·	Application No.	Applicant(s)
Notice of Allowability	10/698,266	WENSTRUP ET AL.
	Examiner	Art Unit
	Vinh T. Luong	3682
The MAILING DATE of this communication appears on the cover sheet with the correspondence address All claims being allowable, PROSECUTION ON THE MERITS IS (OR REMAINS) CLOSED in this application. If not included herewith (or previously mailed), a Notice of Allowance (PTOL-85) or other appropriate communication will be mailed in due course. THIS NOTICE OF ALLOWABILITY IS NOT A GRANT OF PATENT RIGHTS. This application is subject to withdrawal from issue at the initiative of the Office or upon petition by the applicant. See 37 CFR 1.313 and MPEP 1308.

IITLE Bolted Pilot Web with...
S.N. 10/698,266 File: 1-16404

Fig 4

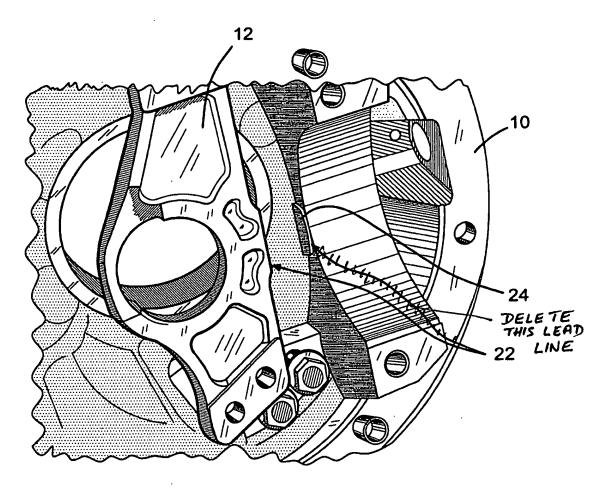
- 1. The Amendment filed on August 9, 2006 has been entered.
- 2. The drawings were received on August 9, 2006. These drawings are accepted by the Examiner subjected to the amendment below.
- An examiner's amendment to the record appears below. Should the changes and/or 3. additions be unacceptable to applicant, an amendment may be filed as provided by 37 CFR 1.312. To ensure consideration of such an amendment, it MUST be submitted no later than the payment of the issue fee.
- The following changes to the drawings have been approved by the examiner and agreed 4. upon by applicant as seen in attached sheets:
- (a) In Fig. 2, add the referential numeral 22 to indicate the first stop claimed in claim 1; and
- (b) In Fig. 4, delete the lead line from the referential numeral 22 to the second stop 24.

In order to avoid abandonment of the application, applicant must make these above agreed upon drawing changes.
